ADDENDUM NO. 2

Date: 04/24/2023

**Project: Project #: 0530-434
Luther Burbank High School Core Academic Renovation, Phase 2**

A1.12
AD2.1

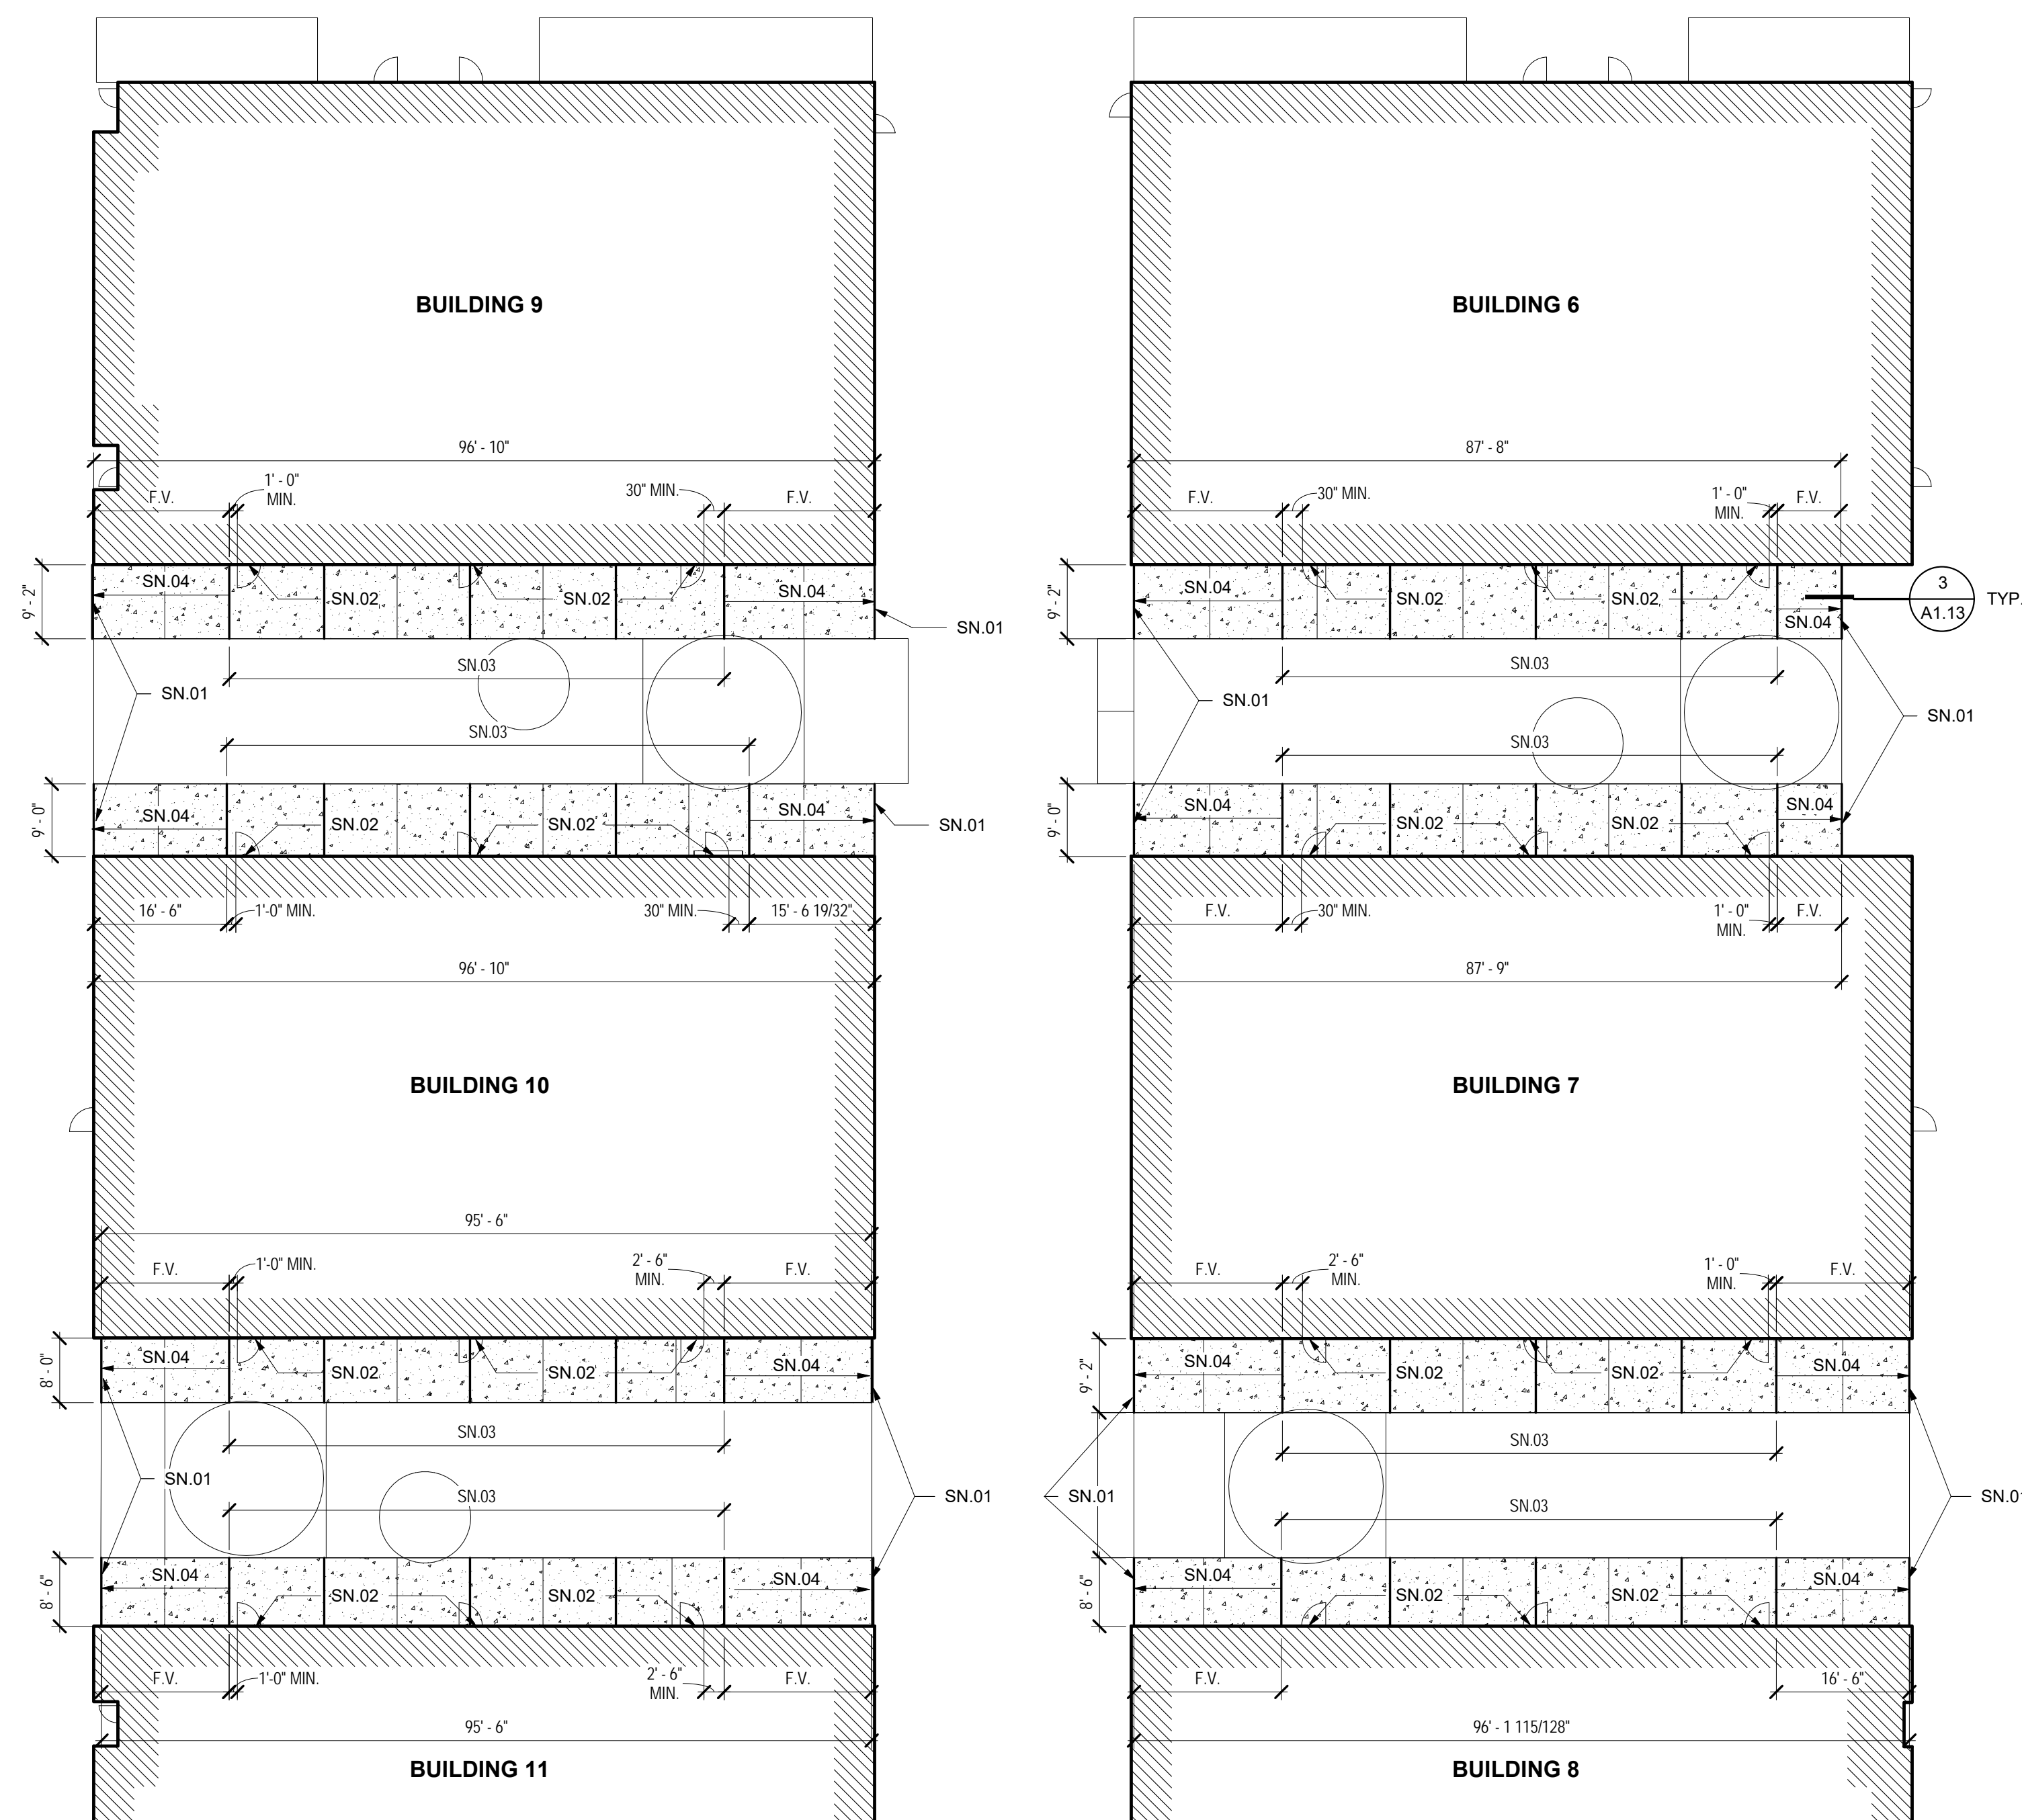
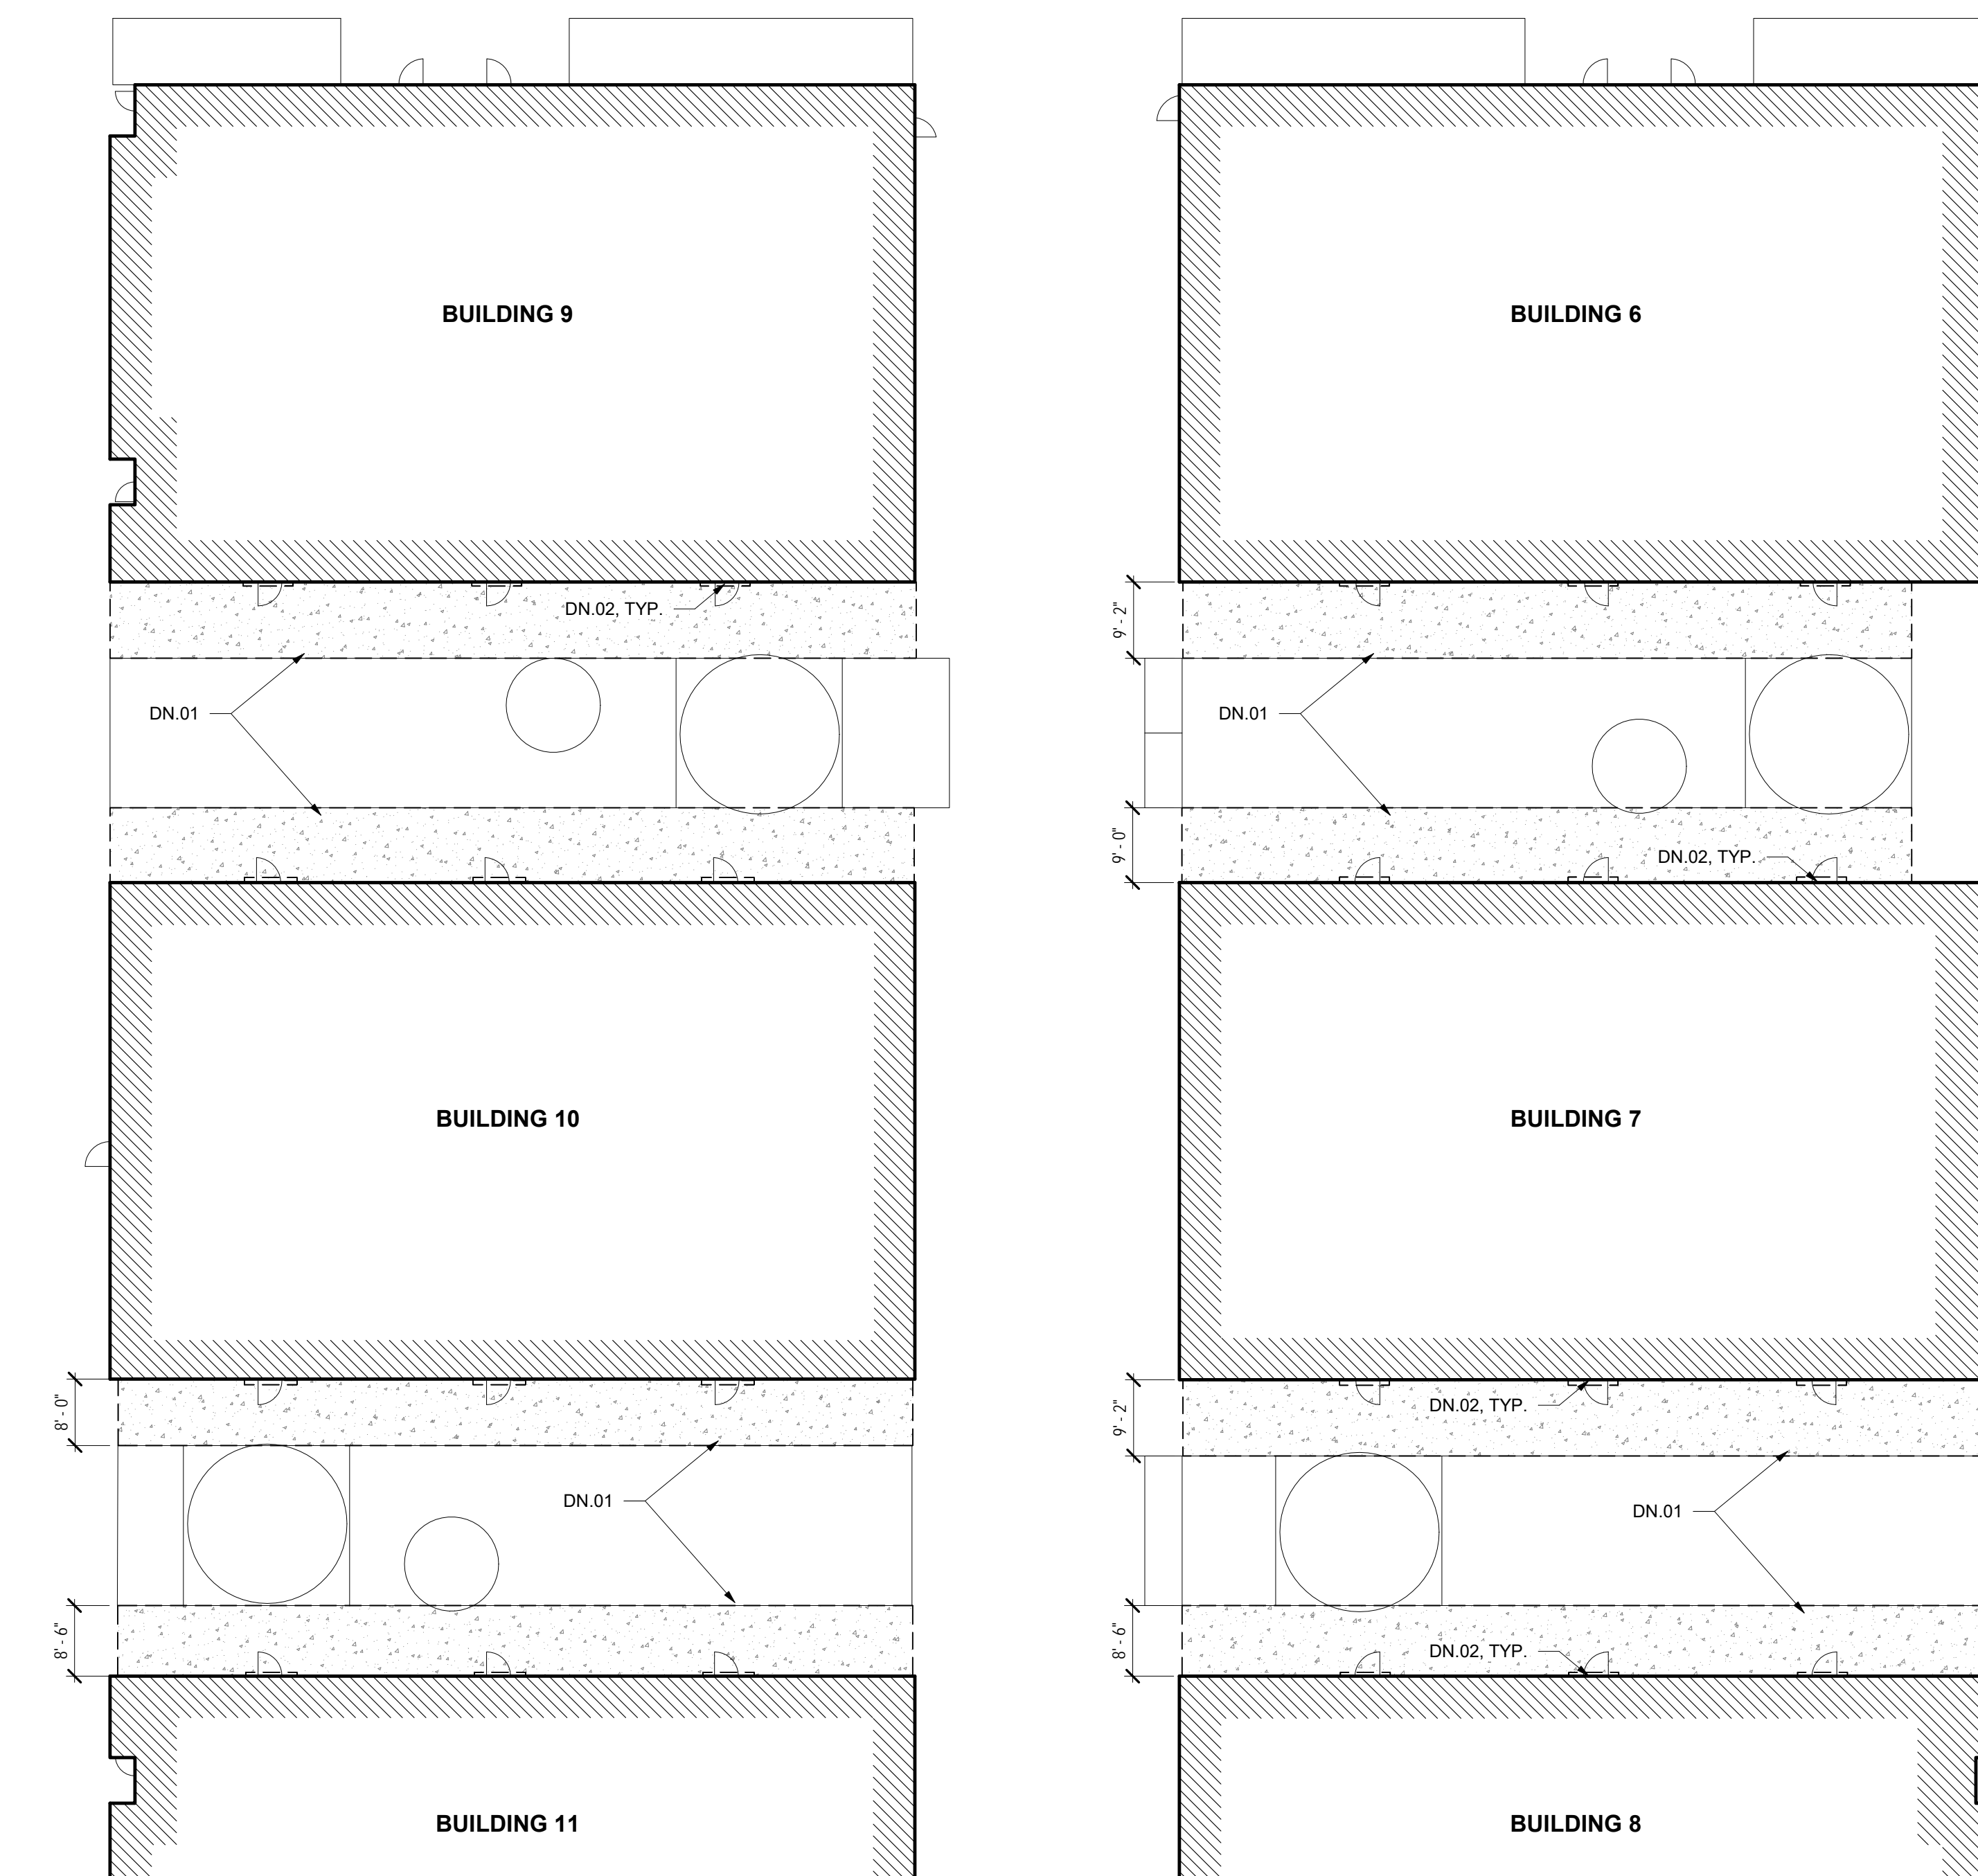
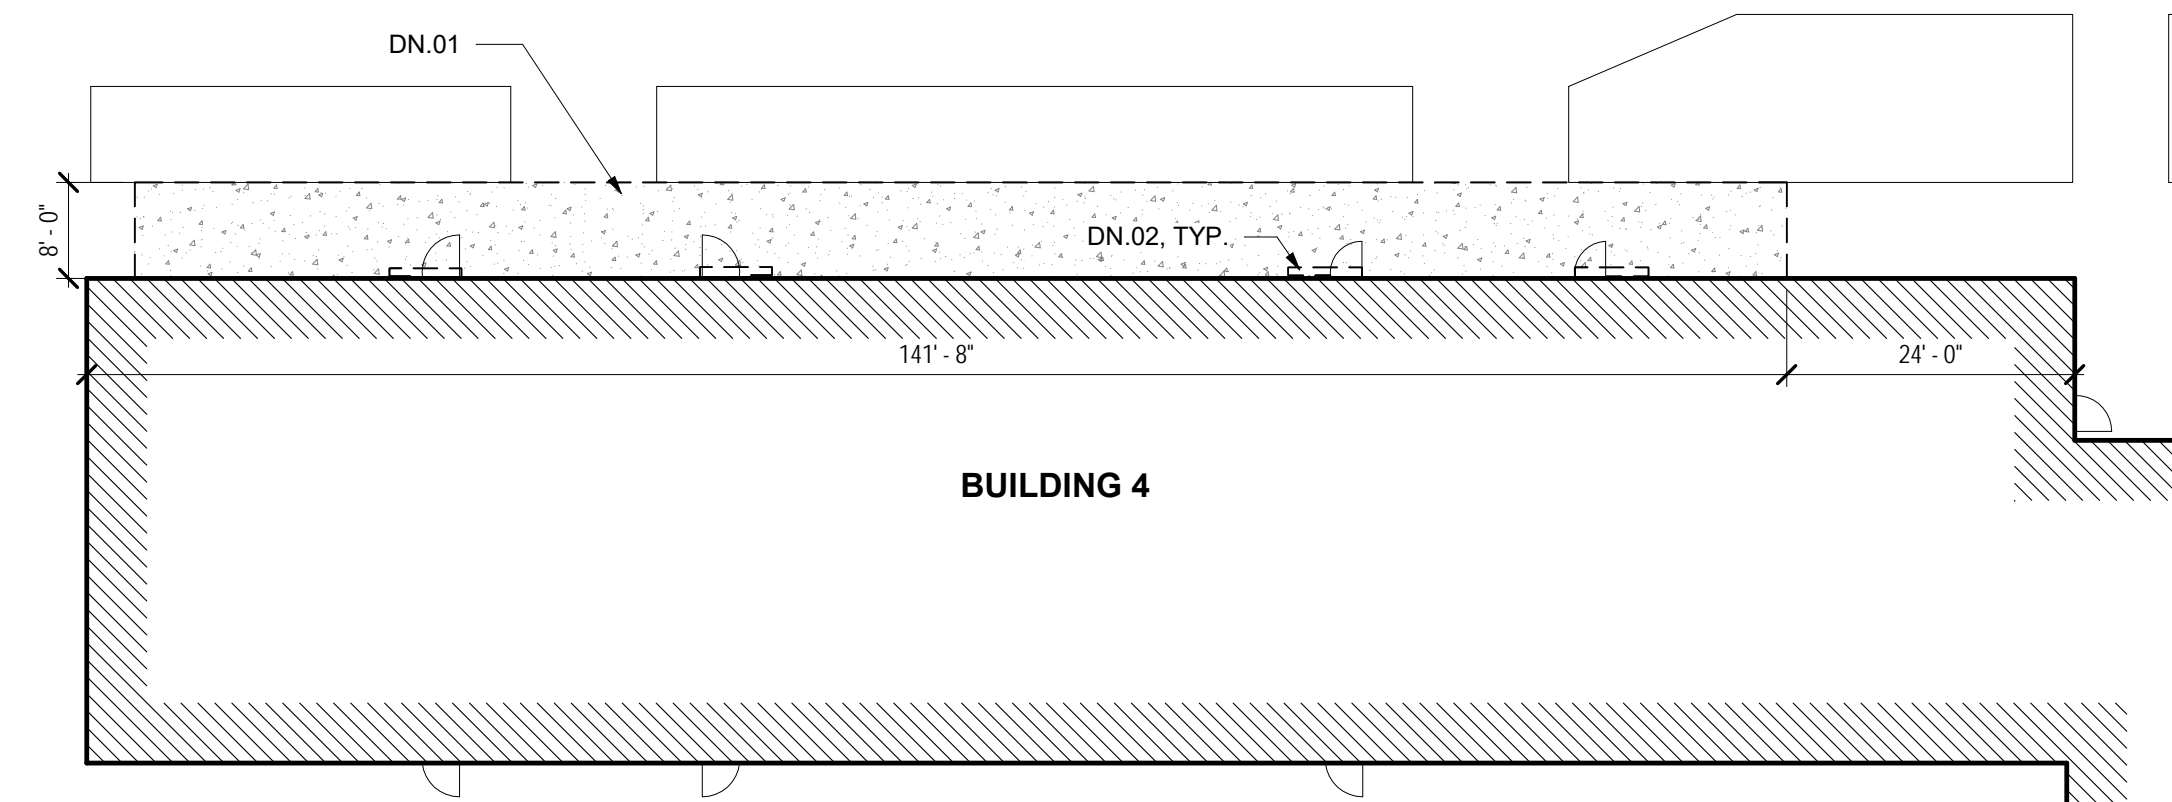
Delete drawing A1.12 and replace with the drawing AD2.1 Enlarged Site plans dated 07/25/10.
